SUNSET VILLAGE FILING NO. 4

CONSTRUCTION PLANS

**CONSTRUCTION DRAWINGS AMENDMENT,
DATED APRIL 4, 2026 BY ENGINEERING LOCAL
XPRTS, LLC.**

REVISION 1: 01/07/2022
COR218 REVISION 2 (ELX
JULY 2026)

DRAWN BY: CDS
REVIEWED BY: CDS
PROJ. MNGR.: CDS

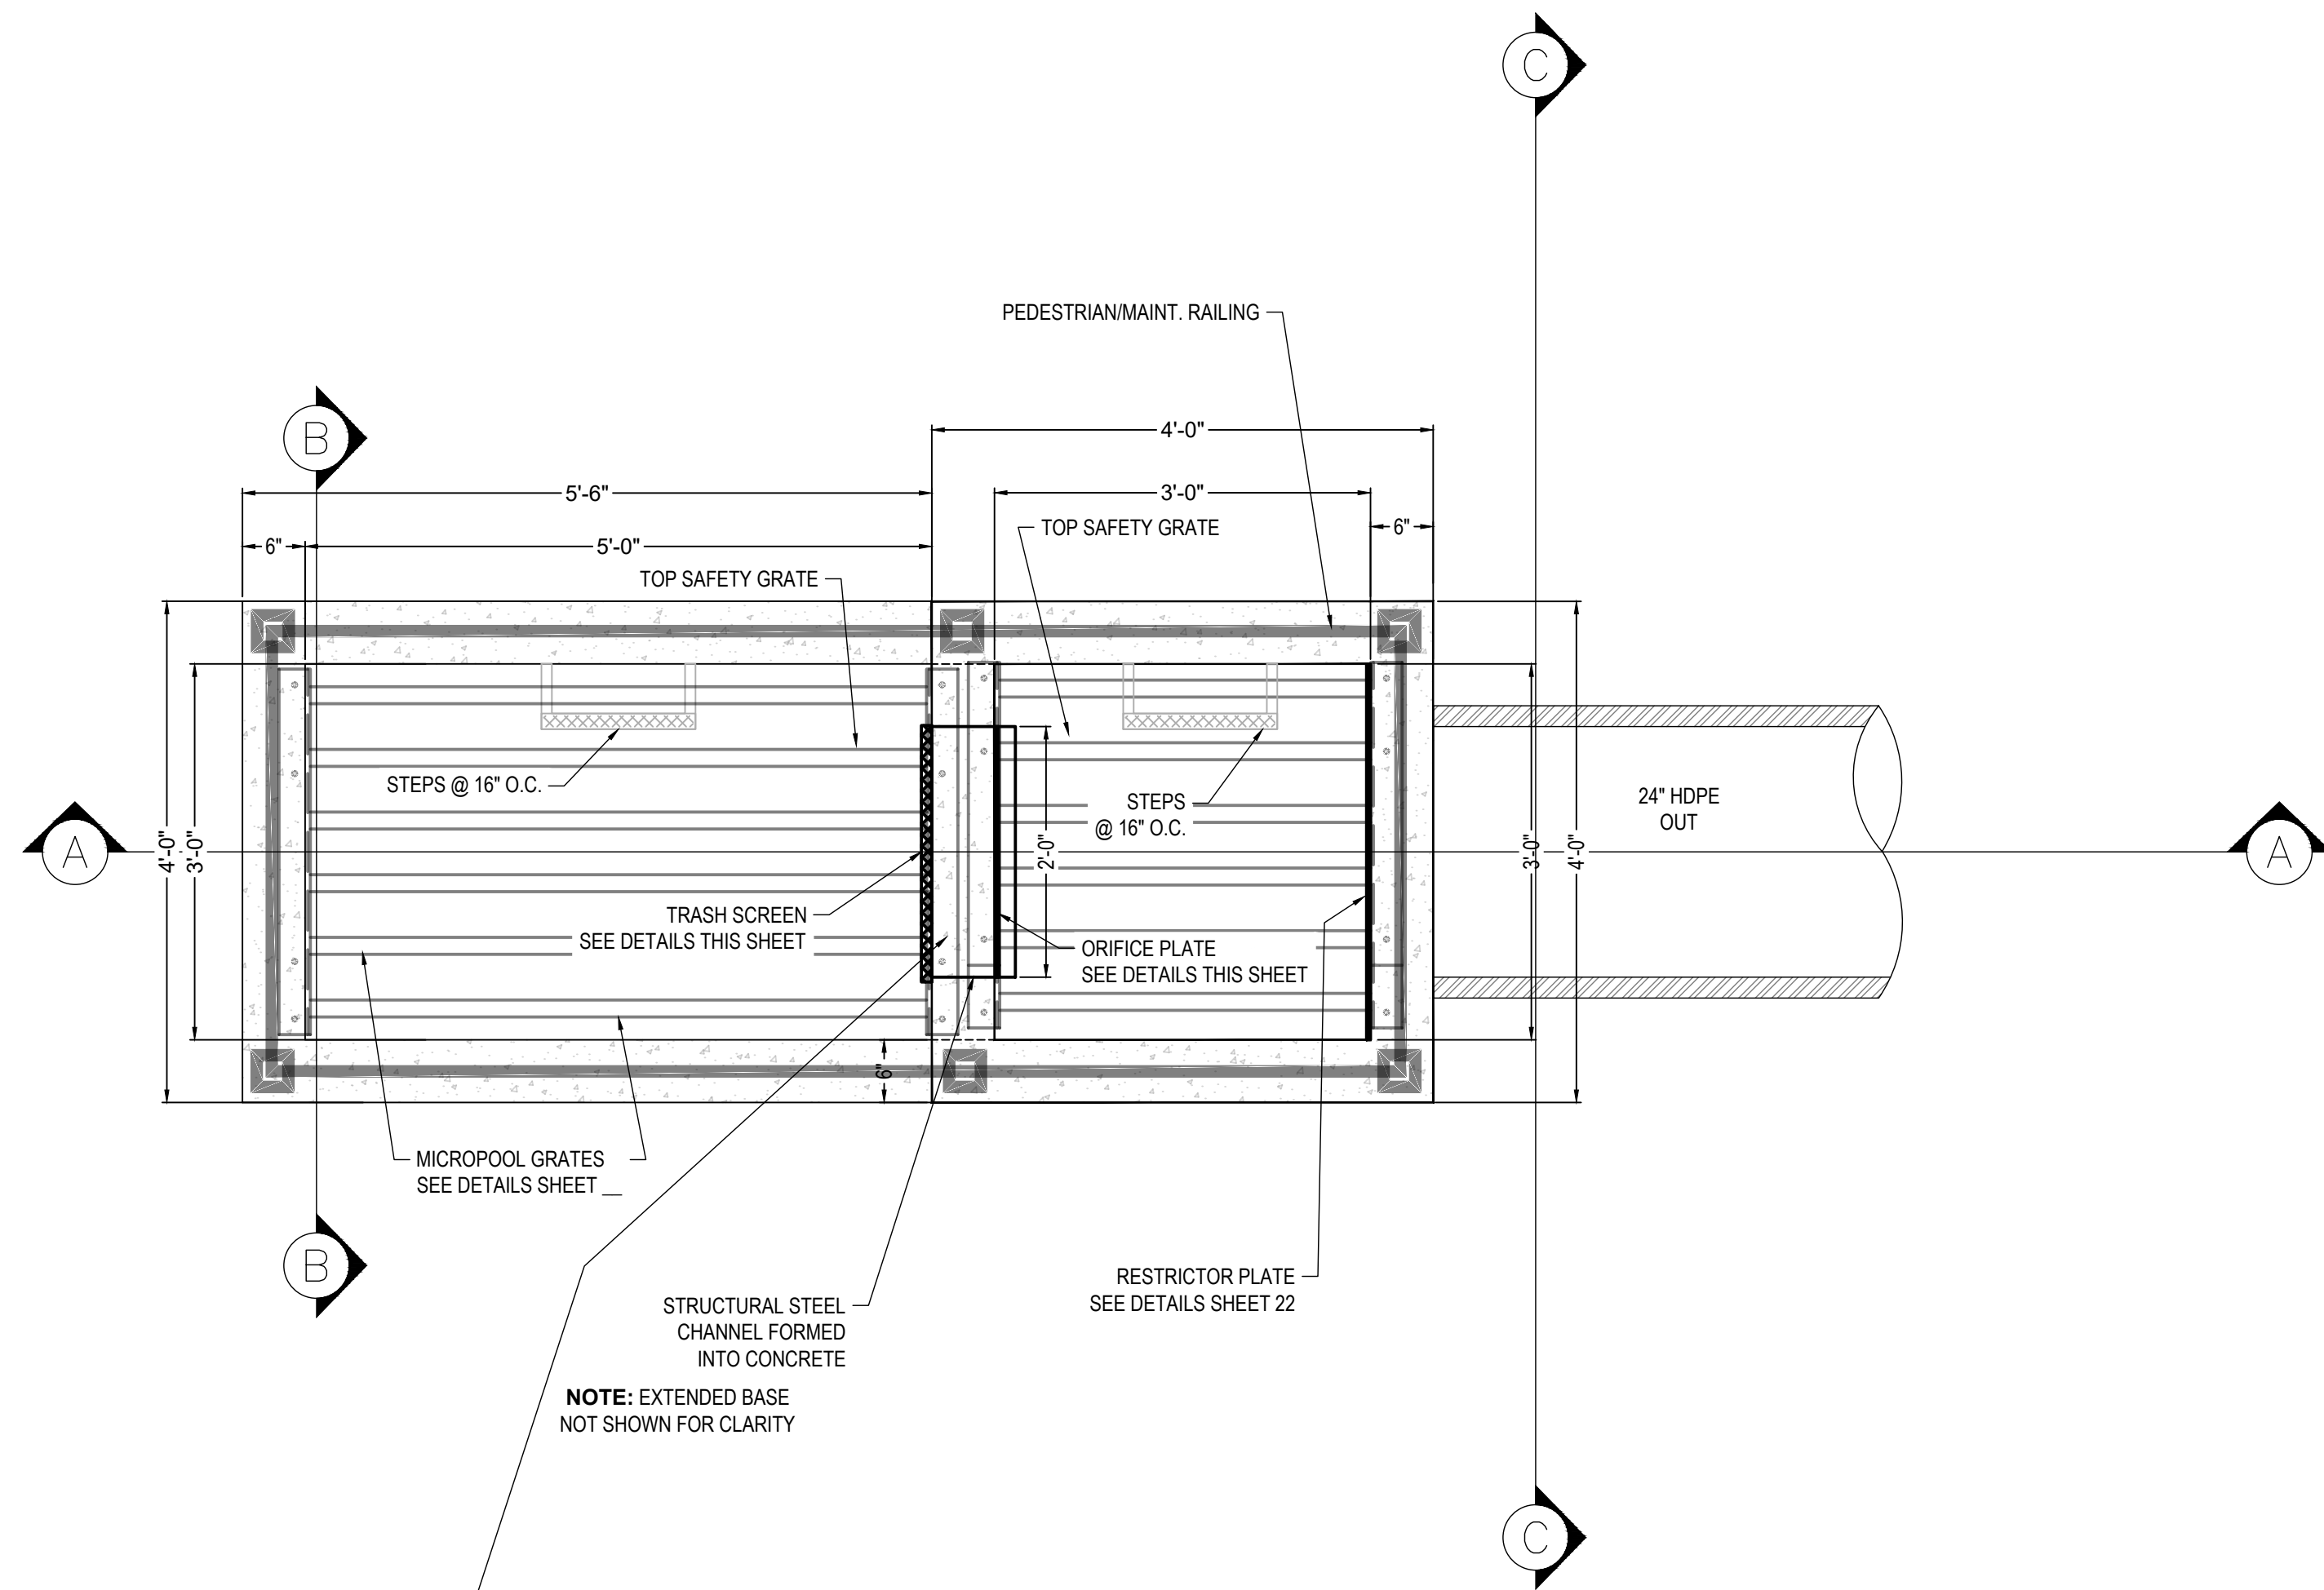
09/22/2026
ELX REVISION #2
